SERVICE BULLETIN

Title: 19XL/XT, 19EX, 19XR/XRT
High Voltage Terminal Installation

Number: C9619

Procedure for assembling and installing the new ceramic high voltage terminals (See [figure 1](#)). Part number 02XB05003001.

Figure 1 — Hi Voltage Terminal Detail

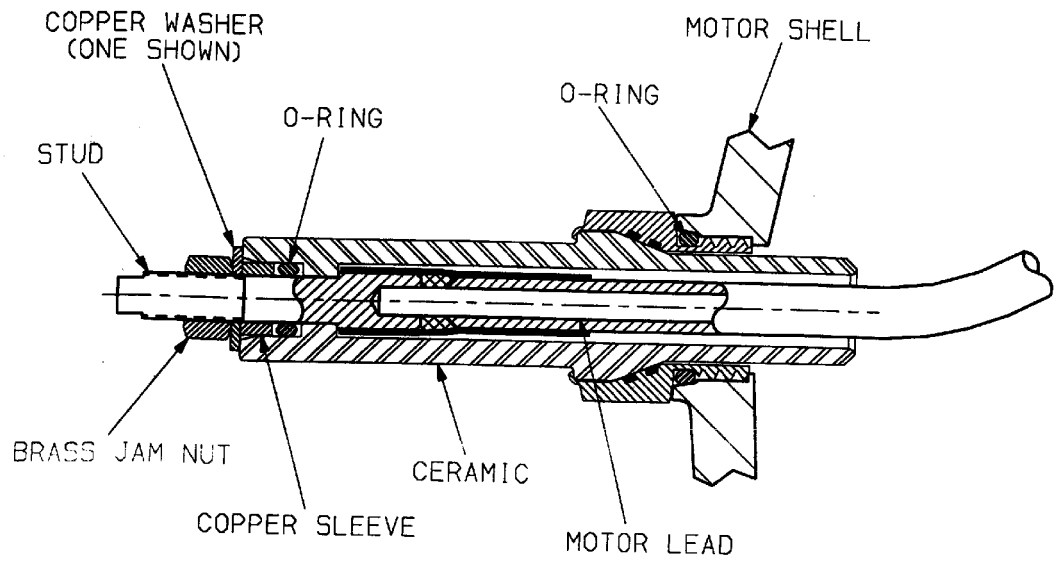
Production has now made the change to the new ceramic terminal on 19 series high voltage motors. These replace the plastic terminals whose installation was outlined in C9504. The following procedure is for the assembly and installation of the new ceramic high voltage terminal only.

1. Inspect and clean the terminal and the machined mating surface of the motor shell or terminal plate with emery cloth or fine sand paper to ensure a leak tight assembly. Lubricate insulator o-ring and mating surface with o-ring lubricant (Parker Super O lube).
2. Slide insulator over the motor lead and thread insulator into motor housing. Torque insulator to 50 ft-lbs (68 Newton-Meters).
3. Lubricate terminal stud o-ring and slide the o-ring over the threaded portion of copper stud, then install the copper sleeve.

IMPORTANT: The copper sleeve which contacts the o-ring, packaged with the terminal, has been selected to properly fit the ceramic terminal body inside diameter. Do not mix terminal insulators and sleeves, use only the sleeve provided with each individual terminal.

4. Slide the copper washer over the stud and next to the copper sleeve. (If replacing an old plastic terminal and not the terminal stud two washers will be necessary because of the difference in length between the two insulators.)
5. Install the brass jam nut and tighten against the washer(s) to a maximum of 3 ft-lbs (4 Newton-Meters) while holding copper stud. This will seat copper washer against insulator and draw internal shoulder on copper stud against the internal edge of insulator.
6. If leakage occurs after the terminal is assembled, then the parts are defective and should be replaced. Do not over tighten in an attempt to eliminate leaks.

Figure 2 — Terminal Stud

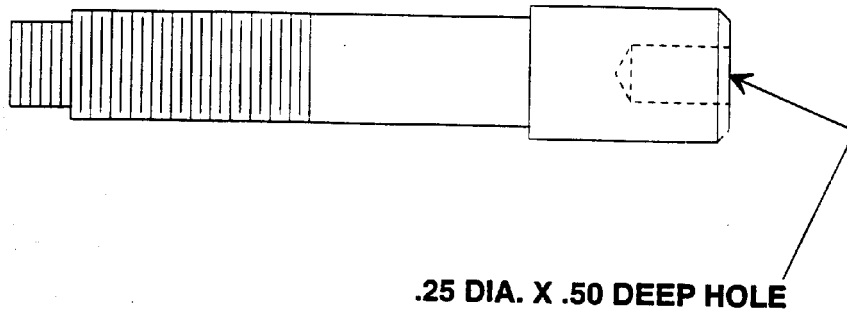
The new ceramic terminal can be used as a direct replacement for the plastic terminal without changing the stud. Replacement terminal studs are available if necessary through RCD. The part number is 19XR660019 (see [figure 2](#)). The hole in the end of the stud is .25 in. (6.4 mm) diameter by .5 in. (12.7 mm) deep. It may be necessary to enlarge it to accommodate larger wires. This stud also requires a 2 bolt connector lug (part number 02XB05002901) for making electrical connections to the terminal.

**DUE TO THE DIFFERENT POSSIBLE GAUGES OF THE MOTOR
LEADS ENLARGEMENT OF THE .25 DIA. HOLE IN THE STUD
MAY BE REQUIRED TO SUIT HEAVIER GAUGE MOTOR LEADS.**
